TYPICAL SECTIONS

CITY OF SAN BERNARDINO
DEPARTMENT OF ENGINEERING
NORTH PARK BOULEVARD
BETWEEN "H" STREET & "F" STREET
CURB & GUTTER, PAVING

SECTION "B-B"

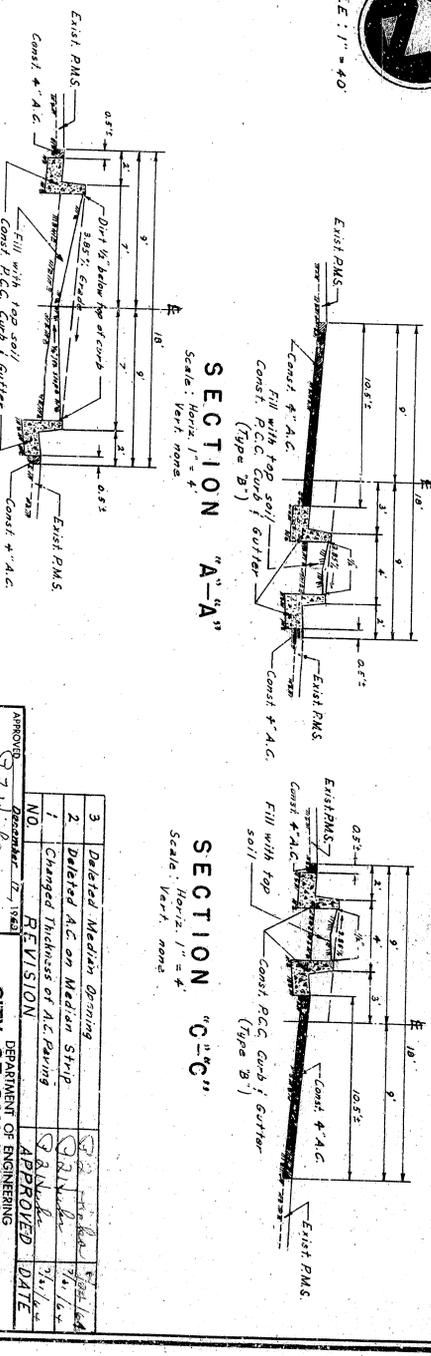
NO.	REVISION	DATE
1	Deleted Median Opening	3/1/12
2	Deleted A.C. on Median Strip	3/1/12
3	Changed Thickness of A.C. Paving	3/1/12

SECTION "B-B"

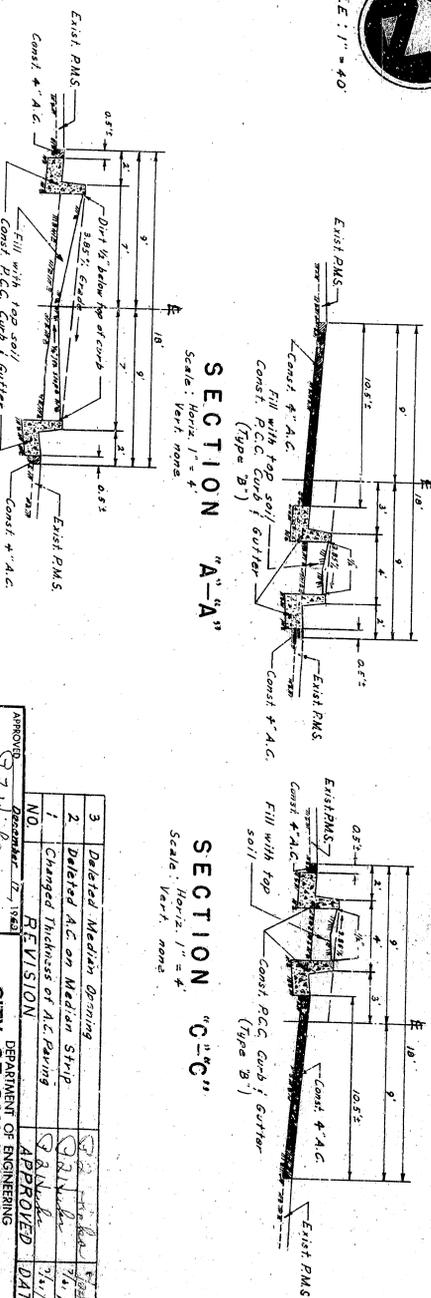
NO.	REVISION	DATE
1	Deleted Median Opening	3/1/12
2	Deleted A.C. on Median Strip	3/1/12
3	Changed Thickness of A.C. Paving	3/1/12
